Airworthiness Directive: 124

Date: September 7, 2001

Subject: S-7 Trim Tab Flutter

Models Effected: S-7 Courier from Serial Numbers 85002 Thru 0396181.

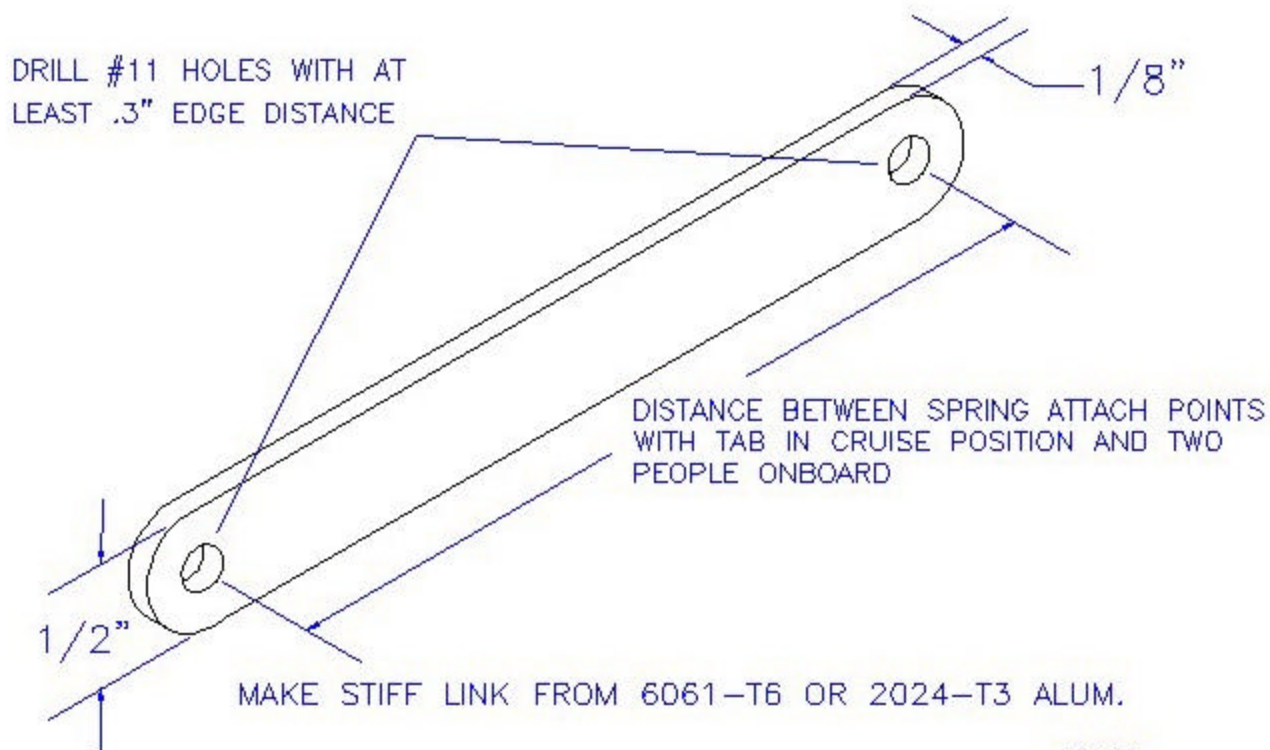
A report of trim tab flutter on S-7's equipped with cable and spring systems require the spring to be removed and a stiff link to be installed. This is a temporary solution as a permanent solution is being developed.

Please remove the spring and install a stiff link as show below. The link can be fabricated from 1/8" aluminum sheet. Adjust the length to match to the spring length when plane is at cruise speed with two onboard. Make additional links until the desired trim setting is reached.
